Building Conservation comments

File Ref: 25/00253/FPH & 25/00254/LBC

Address: Cammocks, Chapel Street, Hinxworth, Hertfordshire SG7 5HN

- **25/00253/FPH** - Conversion of part of barn to form additional annexe ancillary to main dwelling
- **25/00254/LBC** - Internal and external alterations to barn to facilitate part barn conversion to form additional annexe ancillary to main dwelling.

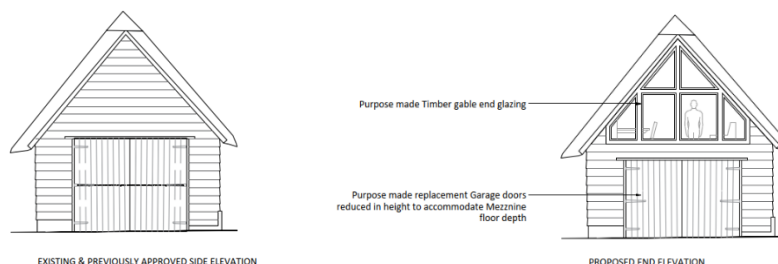
- 4.4 I met with the applicant on site at which I misinterpreted the plans as I thought the existing barn doors were to remain with the new internal first floor dropping down behind the doors effectively creating a bulkhead. This is not the case. The existing opening is to be modified to receive barn doors reduced in height so that the first floor can run through without impeding the opening.

- 4.5 The alternative would be to keep the existing opening/doors and to either create a bulkhead behind or alternatively, step up onto a raised platform where the sofa bed is positioned. The latter is my preferred option and one that I explored with the applicant. I would welcome the architect's thoughts on this.

- 4.6 If the applicant is willing to consider retaining the existing doors (this would minimise works to the building) then the apex glazing would be set slightly higher, thus would cover a slightly smaller area and would therefore have less impact on the listed building. The gable end framing and the existing doors are of no special interest so a modification either way could be made to the gable end without necessarily occasioning harm. However, considering the Google Maps image above there is merit in seeking to slightly reduce the amount of glazing.
